February 11, 1999

**RE: Conditional Approval of GE's *Proposal for Supplemental Source Control Containment/Recovery Measures, January 1999*, by Blaslund, Bouck & Lee, Inc.**

FIGURE 6  
Active and Passive Coefficients with Wall Friction  
(Sloping Backfill)

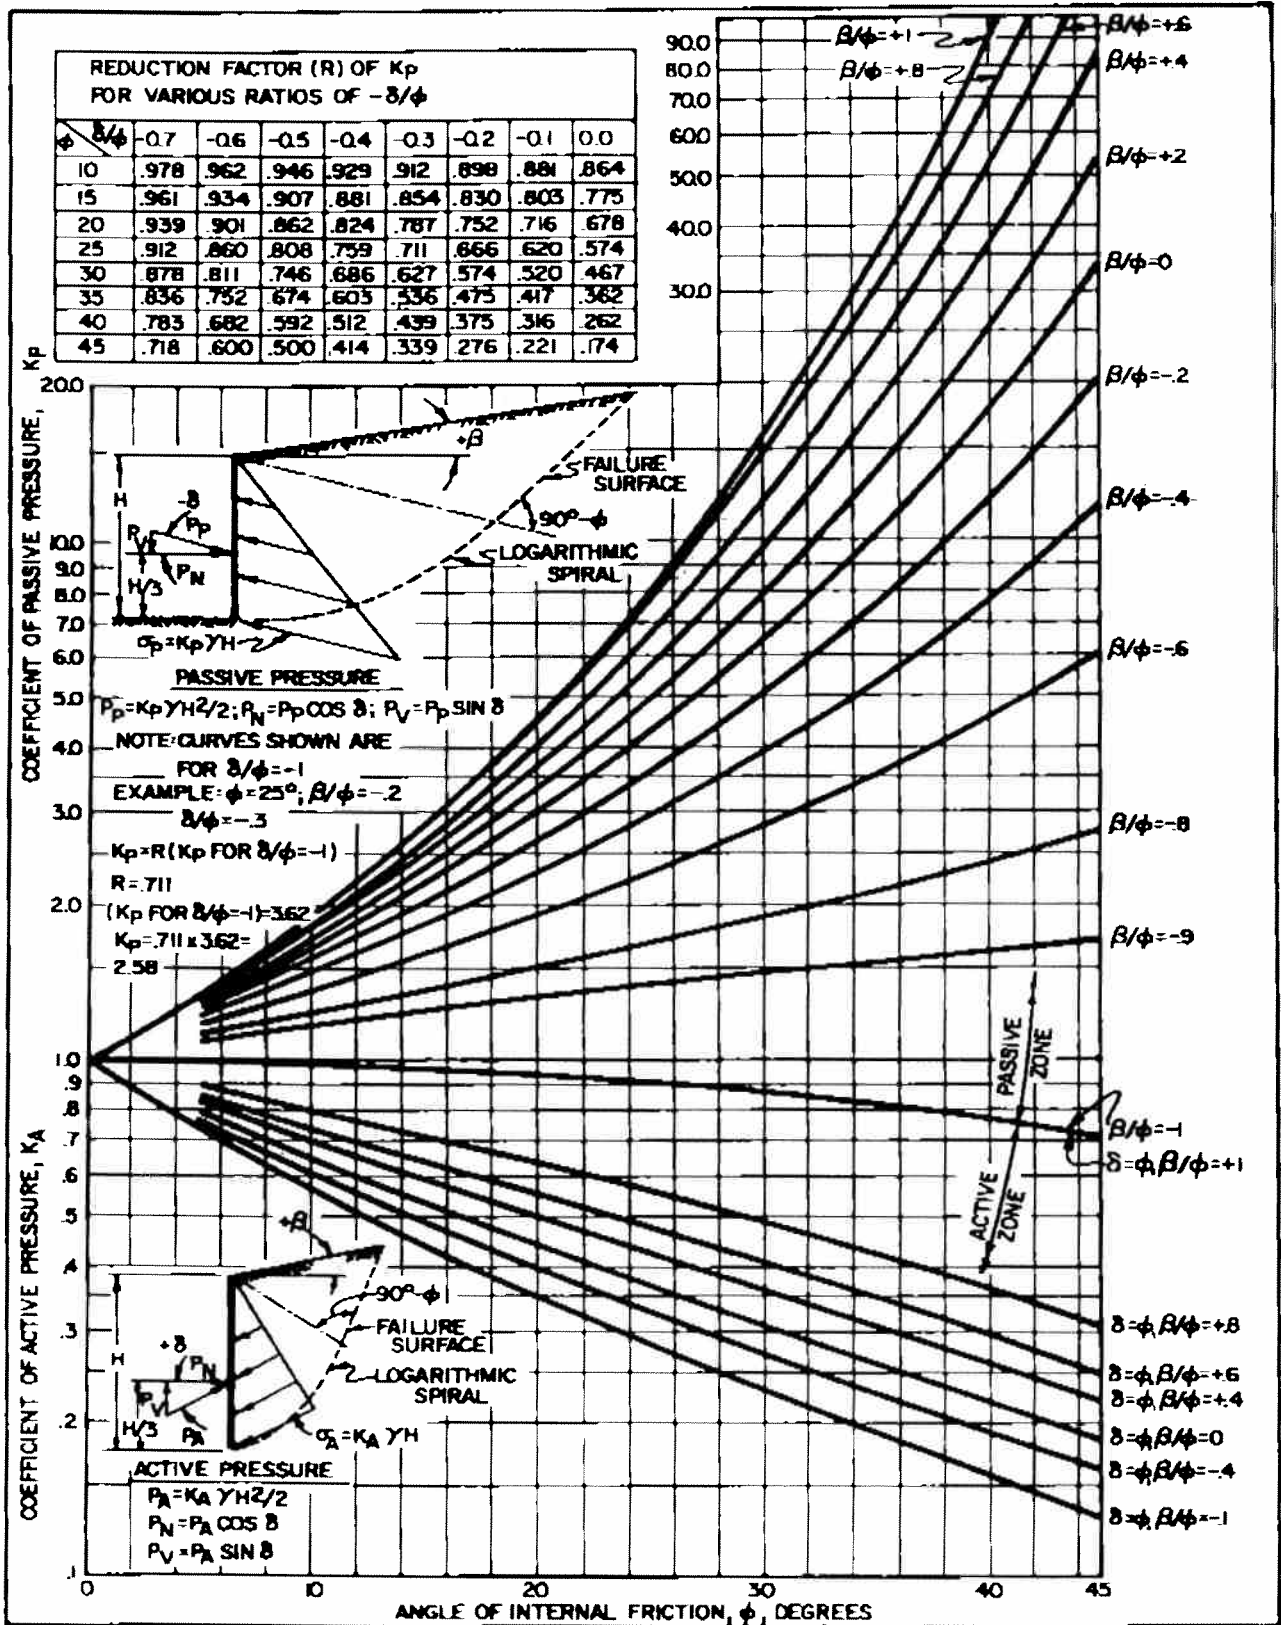
Table 1 from this same reference, the friction angle ( $\delta$ ) between silty sand and sheet piling is  $14^\circ$ , well above the value of zero consistent with a frictionless interface assumption. A more appropriate source for selecting the values of KA and KP for this design would be Figure 6 of this same reference which incorporates both wall friction ( $\delta$ ) and a sloping backfill configuration ( $\beta$ ) into the chart. Please comment and revise as appropriate.

FIGURE 24  
Cantilever Steel Sheet Pile Wall in Homogeneous Granular Soil

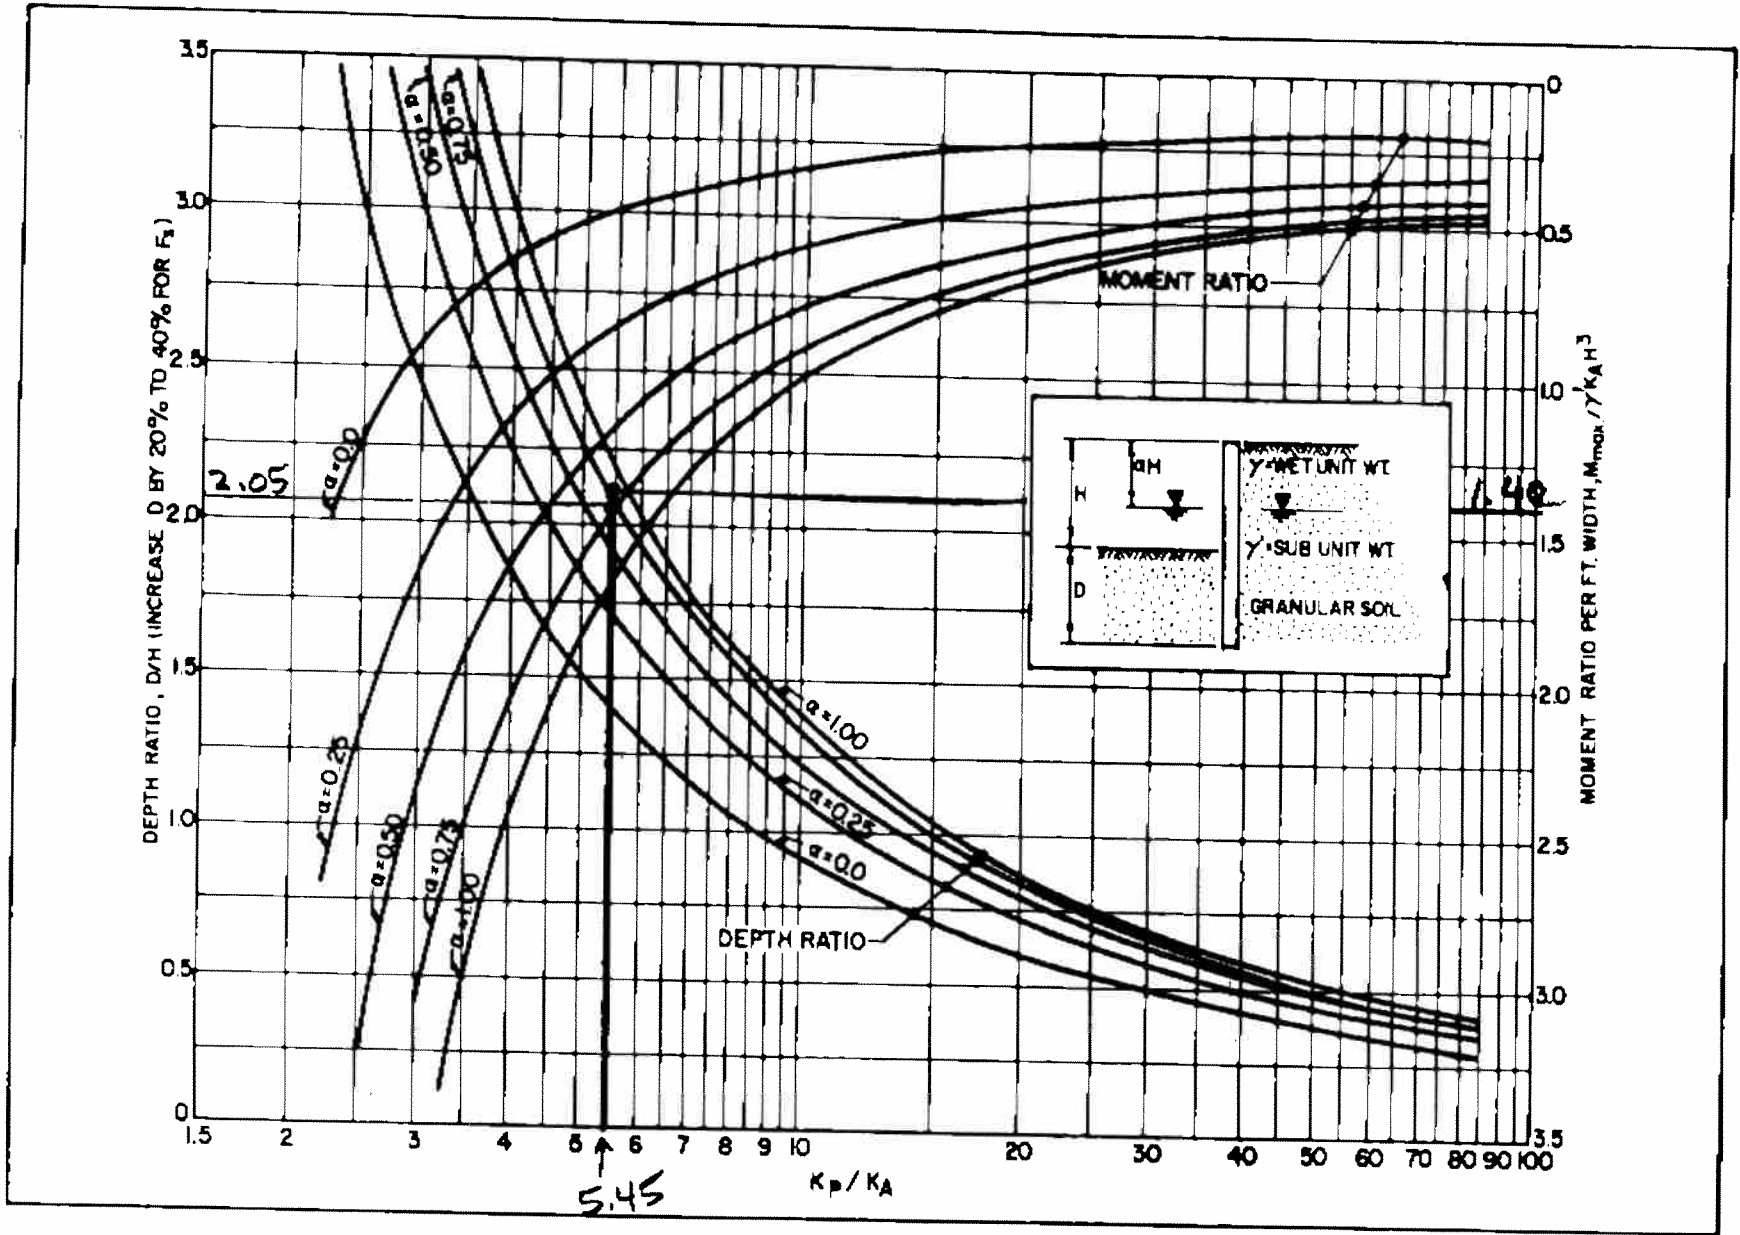
3. Because of the lack of detail regarding the calculation of the maximum moment (from which the sheet piling section was selected) in the computer spreadsheets which document the design, A design chart presented in the Navfac DM7.2 design manual (i.e., Figure 24) has been used to "cross-check" the 7 foot free wall height design. The design chart and related calculations are attached for reference. As shown in the calculations, the required embedment depth of the wall assuming a Factor of Safety (FS) of 1.2 (i.e., the same FS used by BBL) is 17.2 feet as compared to 12 feet as determined by BBL. In addition, the calculated maximum moment which occurs in the section is 16,533 ft-lb/ft as determined from the design chart as compared to 6,973 ft-lb/ft as determined by BBL. This in turn reduces the FS against "breakage" of the sheet piling as defined by BBL (i.e., SALLOW/S) from 6.9 to 2.9 for the Waterloo WZ75 section selected for the construction. **(Note: In the February 3, 1999 meeting, GE and BBL stated that the design would allow for a 9 ½ foot free wall height. This comment still applies.)** Please explain this apparent discrepancy and revise as appropriate.

**Figure 6.6** Cantilever sheet pile penetrating sand

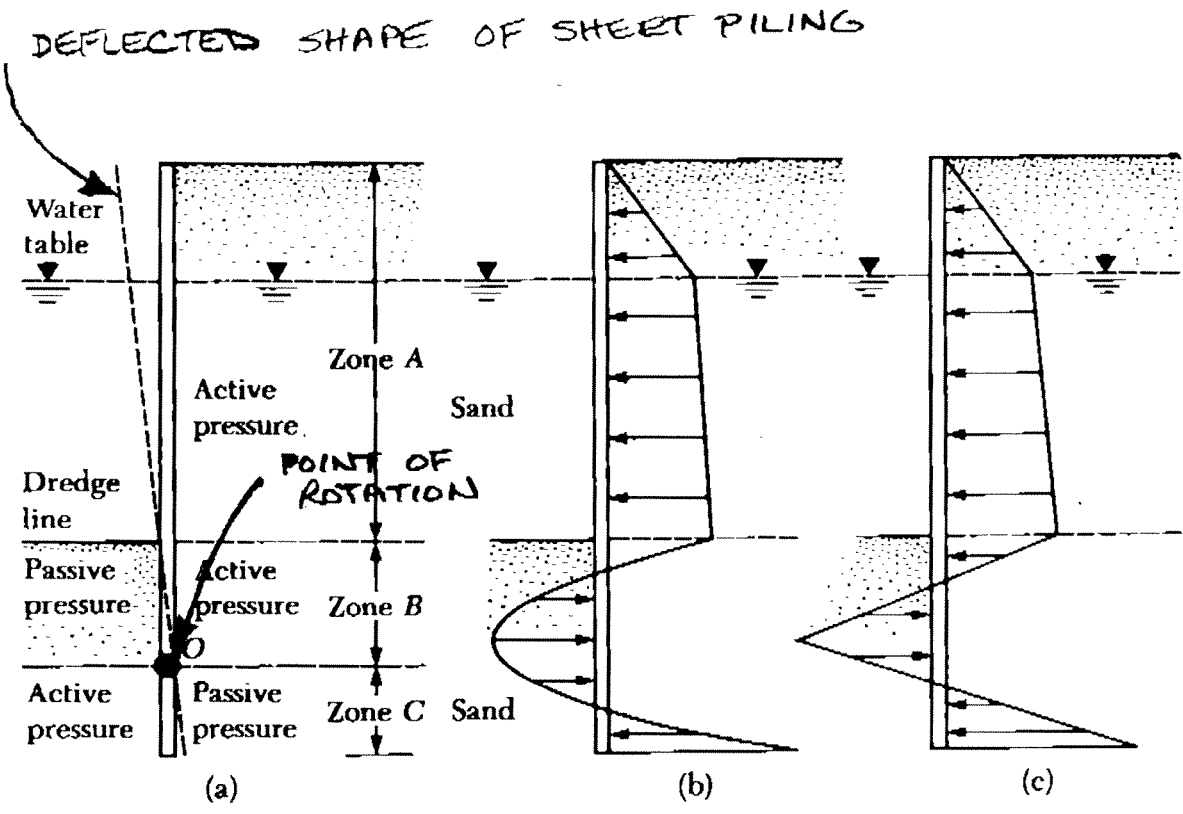
5. The deflected shape of a cantilever sheet piling in granular soil is as shown in Part "a" of the attached Figure 1. This deflected shape causes a combination of active and passive lateral earth pressures to be developed against the wall which results in the assumed lateral earth pressure diagram shown in Part "c" of this same Figure for design of the sheet piling. This assumed deflected shape should have been used by BBL for the "Bending Deflection and Grout Cracking Evaluation" analysis rather than the 3 section deflected shape shown on Page 8 of the Appendix C calculations. This in turn would result in the selection of different lengths and loadings of the cantilever beams which were analyzed to determine the critical (i.e., maximum) deflections from which the analysis was completed. Please comment.
